STAFF RECOMMENDATION
3000 Belmont Boulevard
August 20, 2014

Application: New construction-addition & outbuilding
District: Belmont-Hillsboro Neighborhood Conservation Zoning Overlay
Council District: 18
Map and Parcel Number: 11708015000
Applicant: Steve Durden, Durden Architecture
Project Lead: Paul Hoffman, paul.hoffman@nashville.gov

<p>Description of Project: The applicant proposes a rear addition and outbuilding.</p> <p>Recommendation Summary: Staff recommends approval with the conditions that:</p> <ol style="list-style-type: none"> 1. Lap siding shall have a reveal no greater than five inches (5"); 2. Staff approve the materials for construction of the outbuilding stairs; 3. Staff approve the final details, dimensions and materials of windows and doors prior to purchase and installation; and, 4. Staff approve the roof color and a masonry sample for dimensions and texture; 5. That four inch (4") wood casings be used around doors, windows and vents; and, 6. HVAC and other utilities shall be located to minimize visibility from the street, if they are to be moved. <p>Staff finds that the project meets II.B of the <i>Belmont-Hillsboro Neighborhood Conservation District: Handbook

ROOF PLAN
A-1.3

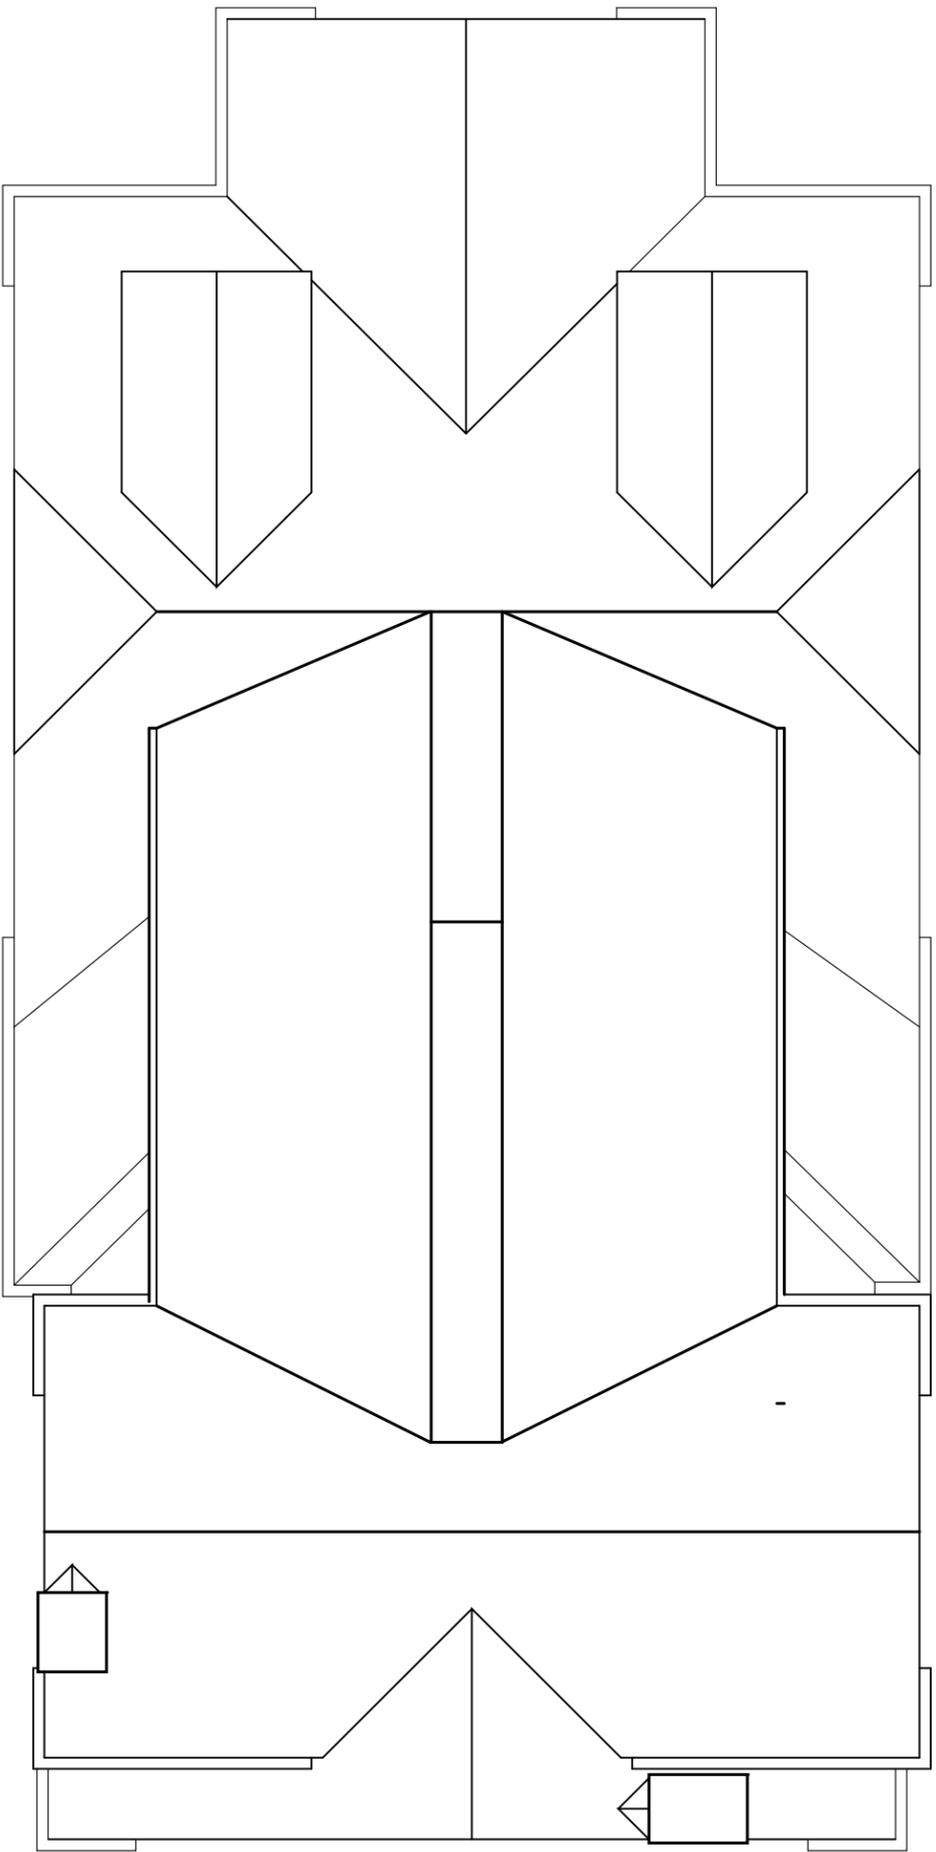
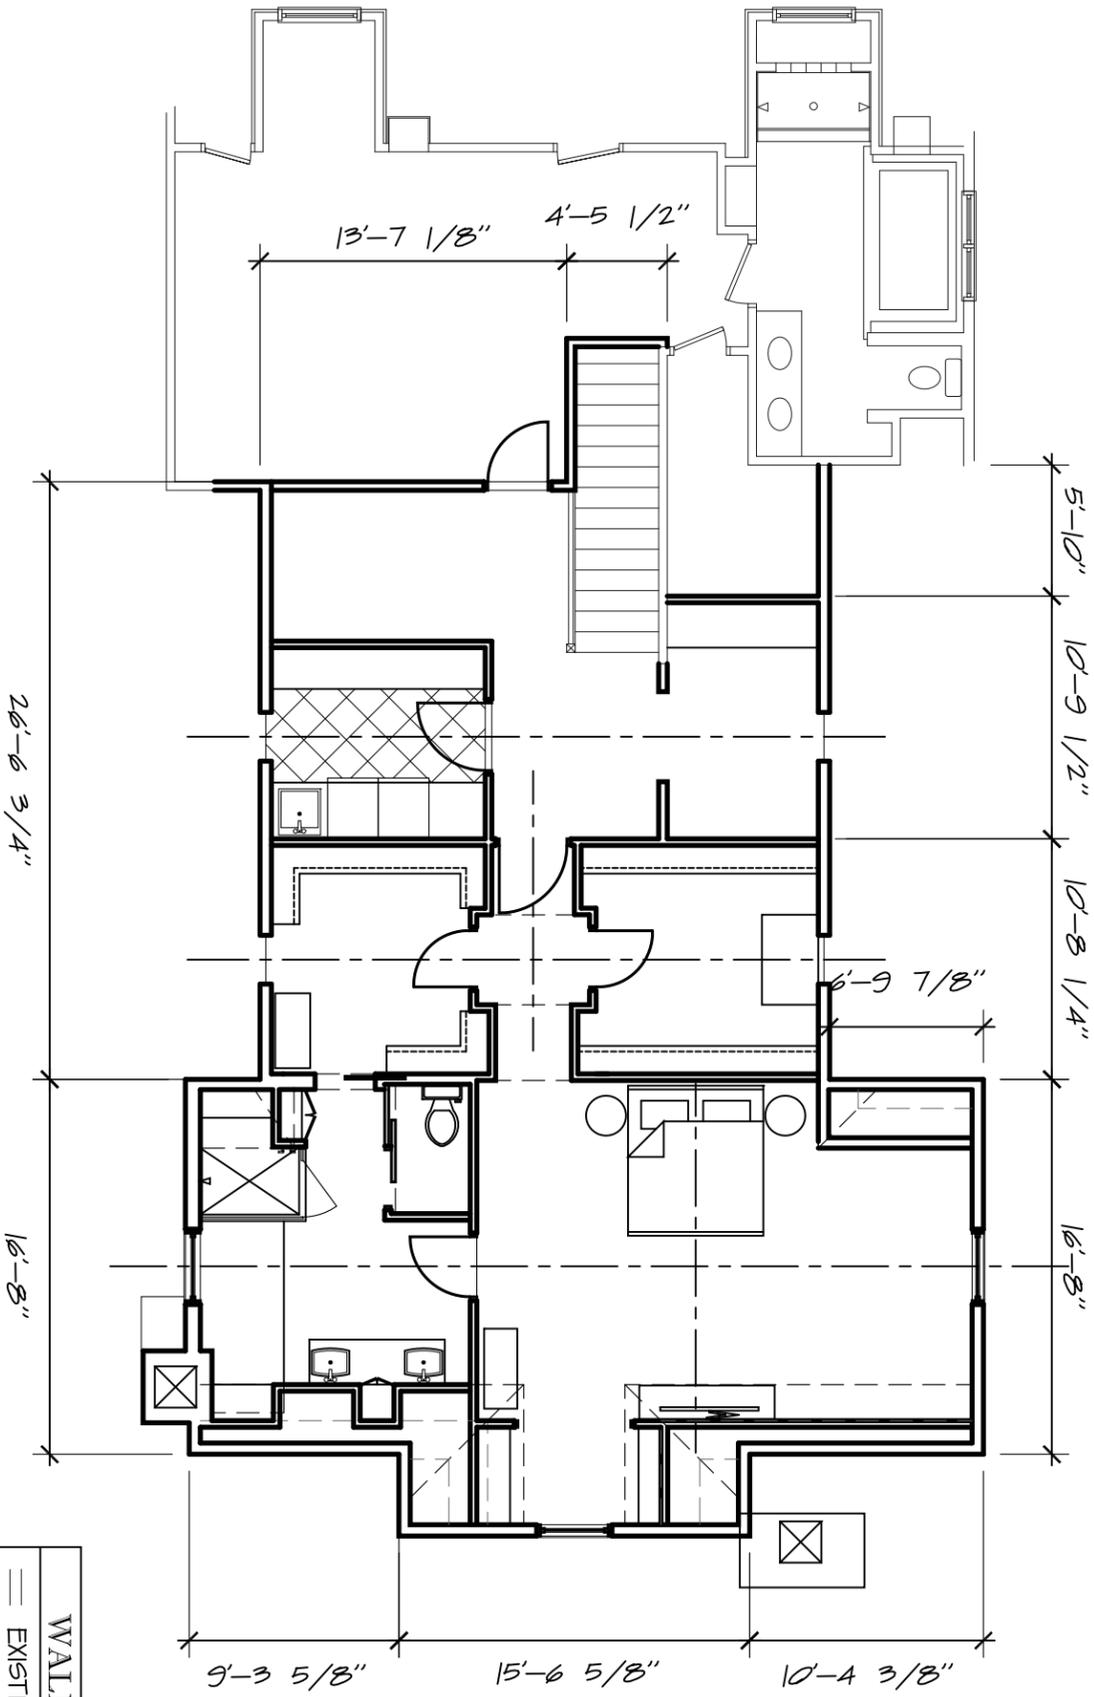
Roof form: The addition will tie into the existing front-to-back ridge of the rear section of the house. A standing seam metal roof with 3/12 pitch will extend back to the rear section of the addition, which has a side-gabled form and 6/12 pitch. The side-gabled portion of the addition's roof helps decrease its visual mass. A shed dormer is proposed on each side of the connection. The project meets section II.B.1.e.

D-1.1

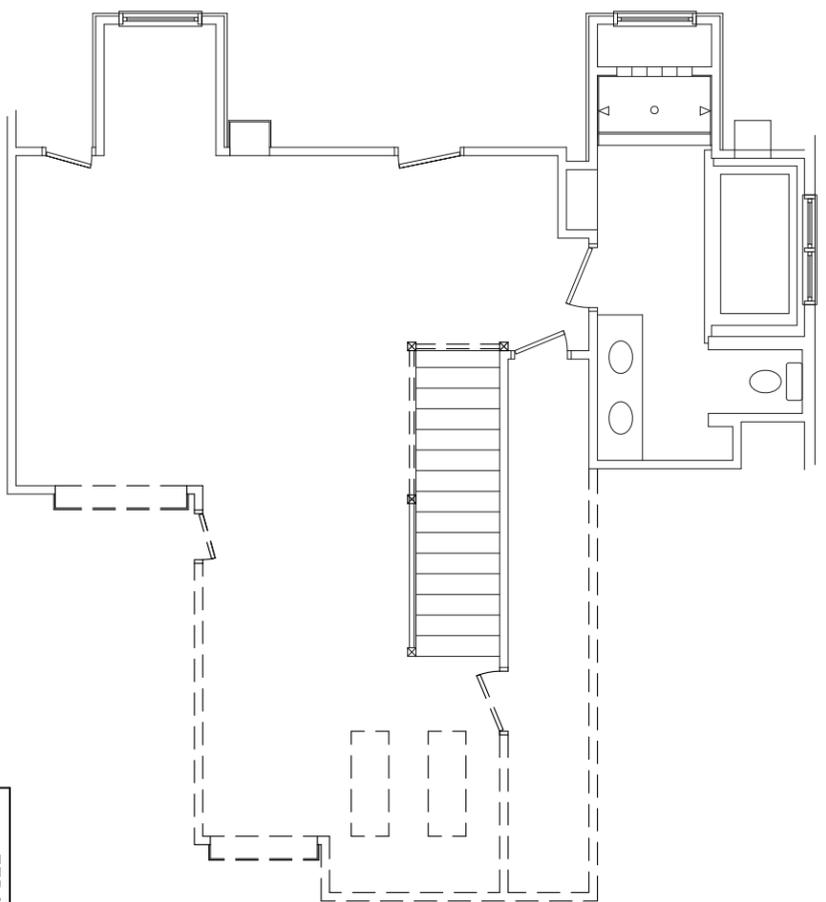
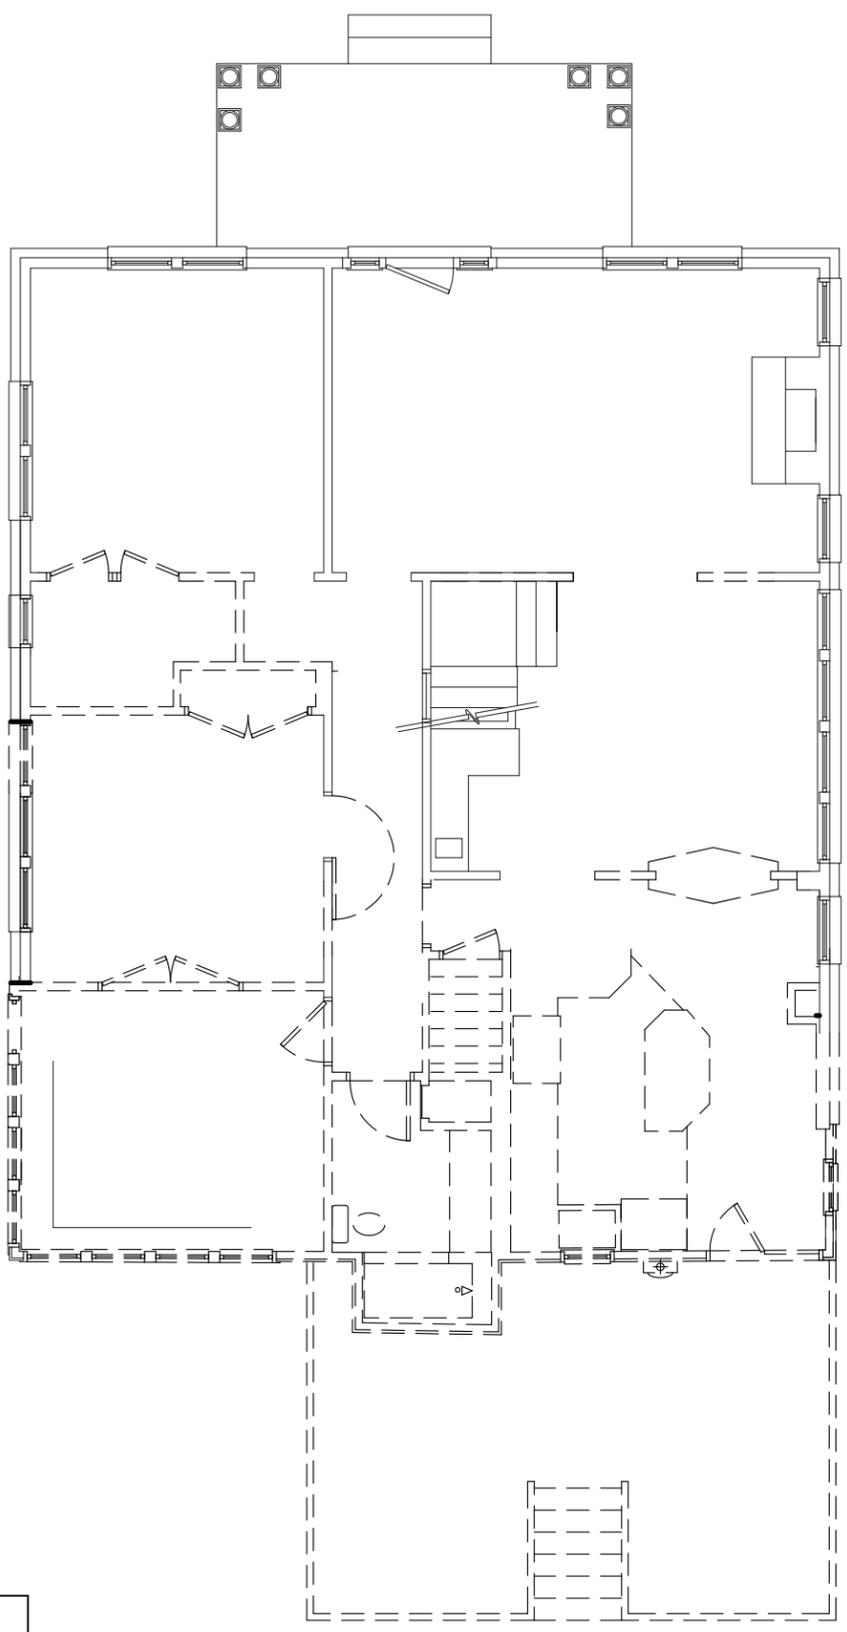
Demolition: The project requires demolition of part of the rear roof and wall of the existing house. An interior chimney which is in poor repair at the rear left side will be removed. The chimney is not a character-defining feature of the house, and this partial demolition is not detrimental to the historical integrity of the building or the district. The project meets section III.B.2 for appropriate demolition and does not meet section III.B.1 for inappropriate demolition.
